STAFF REPORT
COMMUNITY DEVELOPMENT DEPARTMENT

HEARING DATE: 10/7/2021
 TO: Planning & Zoning Commission
 FROM: Alan Tiefenbach, Associate Planner
 208-884-5533
 SUBJECT: H-2021-0044, H-2021-0005
 Elderberry Estates Subdivision
 LOCATION: 1332 N. Meridian Rd

This is a request to rezone from C-C to O-T and a Short Plat of four lots to allow four duplexes.

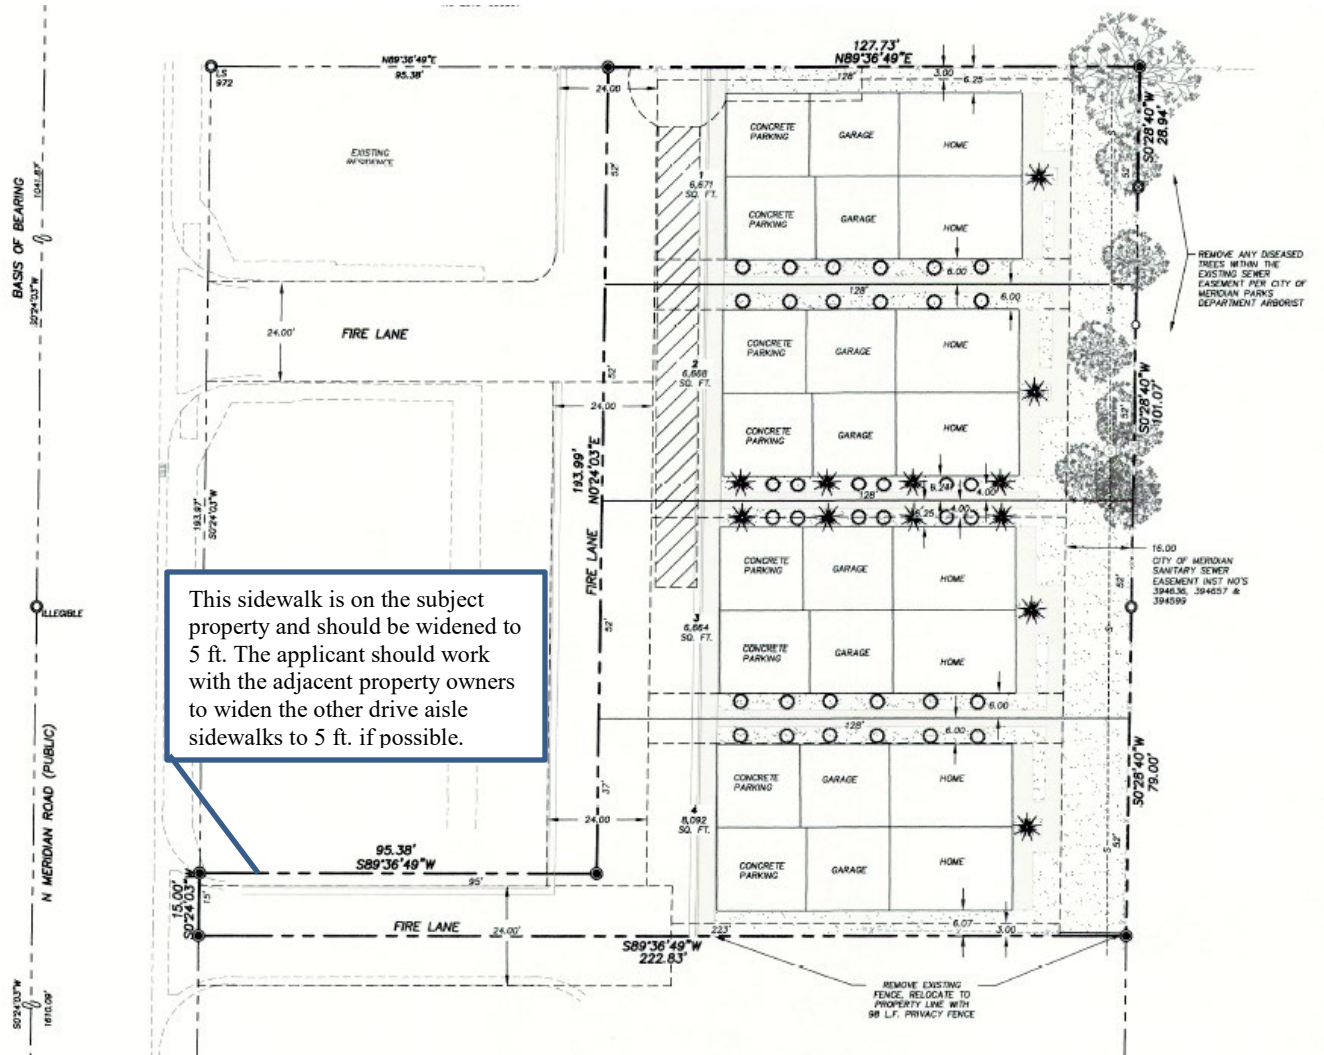
Conceptual elevations were provided with this application. The elevations indicate duplexes with pitched roofs, fishscale accents, shuttered windows with lintels and windowed garaged doors. As is required by the O-T zoning district, the duplexes are at least two-stories, although the elevations do not indicate whether the minimum required 35' height is met.

This project is near the downtown core and is being proposed for Old-Town zoning. Due to the visibility of these two story-buildings, design is critical to this project. The ASM for residential requires visually heavier and more massive elements or materials, such as stone or masonry, primarily at the base of buildings, and lighter elements and materials such as siding. Also, the ASM states primary building entries must be clearly defined using any unique combination of architectural elements, materials, or façade modulation meeting other architectural standards in the Manual. At the time of design review, the elevations should provide front porches over the front doors, overhangs matching the rooflines or porches over the garage doors, and a heavier accent material around the base of the buildings.

1. Administrative design review is required prior to building permit for all new attached residential structures containing two (2) or more dwelling units. Elevations should include at least two field materials, accent materials, a heavier accent material around the base of the buildings, covered porches, and overhangs matching the rooflines or porches over the garage doors.
